MGOZ Q 1/2019 - Quotation for the Hiring and Installation Services of a Public-Address System and Lighting Decorations for Valentine's Day Event at Villa Rundle Gardens

Clarification No. 1

Decorative Lights specifically-Lot 2

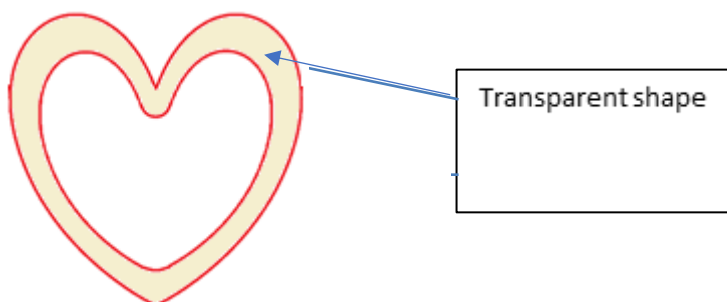
b) Please can you explain what lumens or watts for each uplighter you need?
What beam angle you need?

Spotlights need to be sufficient to illuminate figures from close range.
